DEVELOPMENT ASSESSMENT REPORT	
Application No.	DA/2022/0779
Address	2 Goodsir Street ROZELLE
Proposal	Demolition of existing dwelling, construction of a new two storey dwelling, pool, removal of five trees and landscaping
Date of Lodgement	29 September 2022
Applicant	Mr Mark McFarlane
Owner	Mr Mark D McFarlane and Mrs Ashleigh R McFarlane
Number of Submissions	Initial: 17 Renotification: 15
Value of works	\$742,252.00
Reason for determination at Planning Panel	Number of submissions
Main Issues	<ul style="list-style-type: none"> • Bulk and scale; Solar access; Parking and • Demolition of entire dwelling (Not substantially the same development as original application as lodged sought alterations and additions)
Recommendation	Refusal
Attachment A	Reasons for refusal
Attachment B	Plans of proposed development
Attachment C	Statement of Heritage Significance
Attachment D	Draft conditions in the event the application is approved.

1. Executive Summary

This report is an assessment of the application submitted to Council for demolition of an existing dwelling and construction of a new two storey dwelling, pool, landscaping, tree removal and off street parking at 2 Goodsir Street Rozelle.

LANDSCAPE PLAN

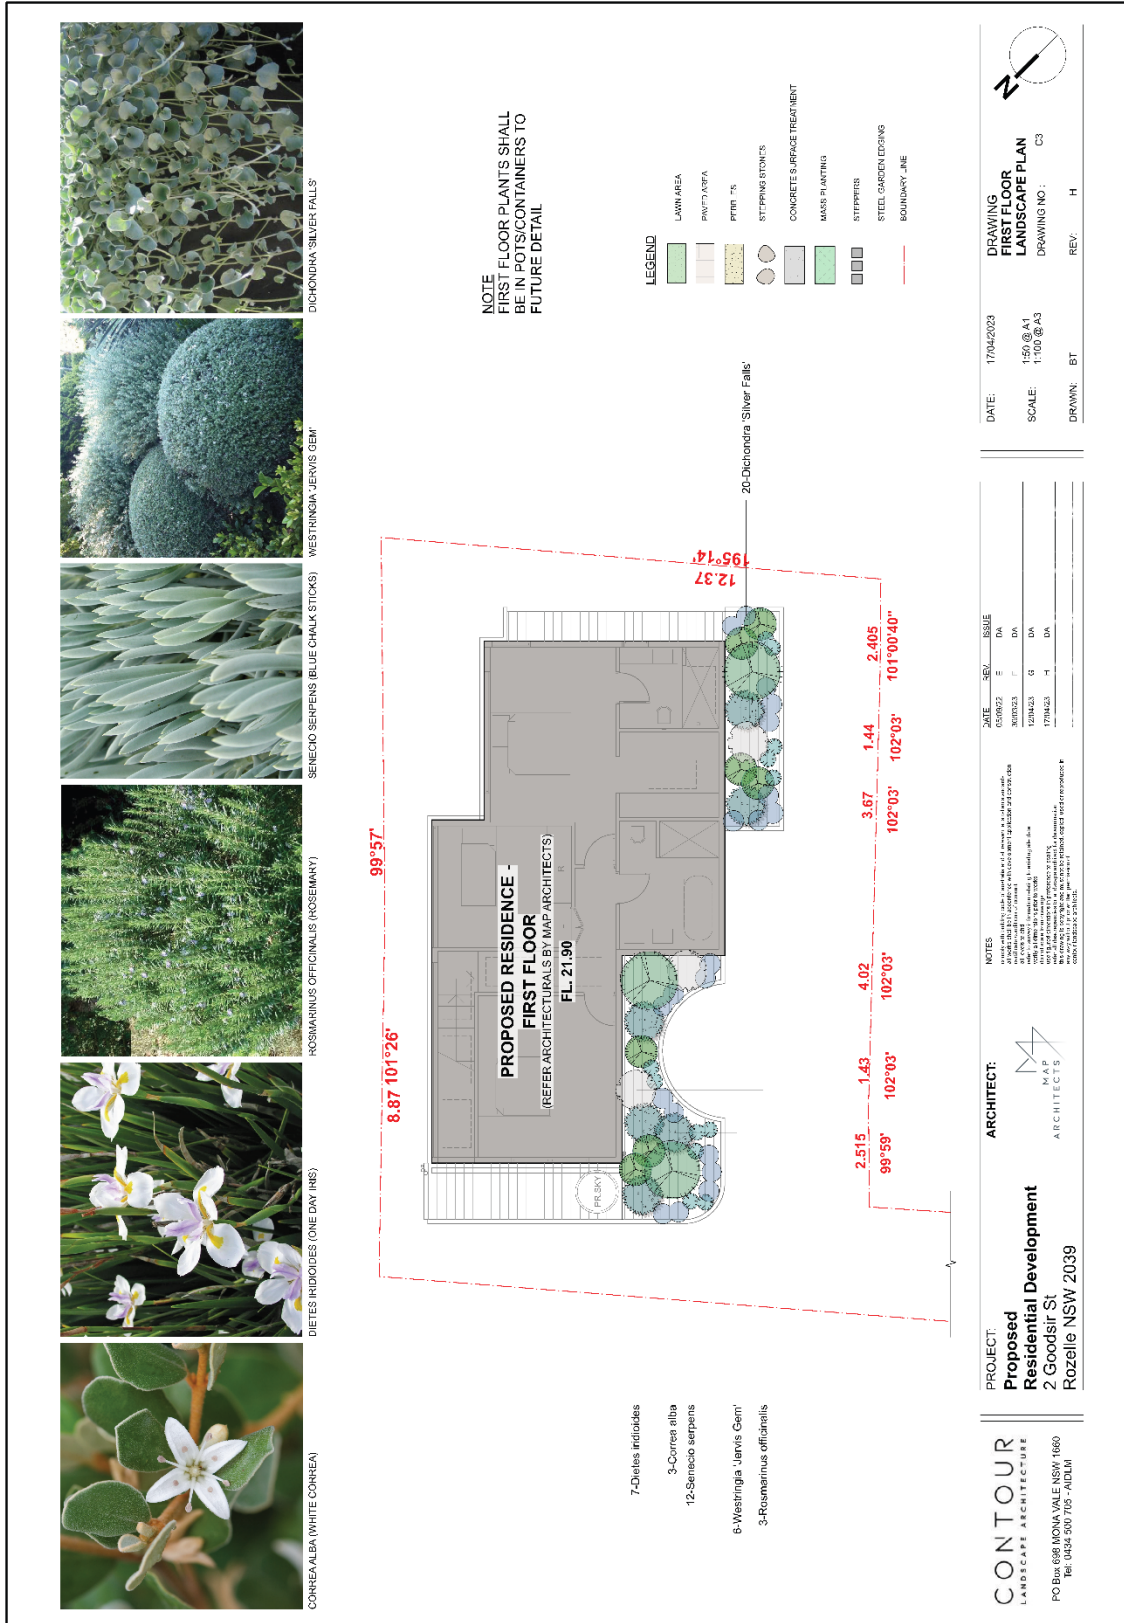
*The Landscape Plans prepared by Contour Landscape Architecture (Rev E, 5/9/22) requires amendment and therefore perhaps should not be stamped. The *Ficus lyrata* (Fiddle Leafed Fig) is the only tree included in the planting however it is not appropriate for the location in which it is shown. The plant schedule indicates that this tree will grow 6 m tall and 1.5 metres wide, however the mature dimensions are generally approx 12m x 10m minimum. Whilst it is acknowledged that the location will constrain the size it is likely that the tree will be far too dense and large for the small courtyard and is likely to be proposed for removal on that basis in the future.*

The Landscape Plan must include a minimum of two (2) replacement canopy trees, appropriately located where they can attain mature dimensions. The south eastern section of the proposed alfresco area may need to be reduced away from the side boundary by a couple of metres to provide an appropriate location for one (1) of the required trees.
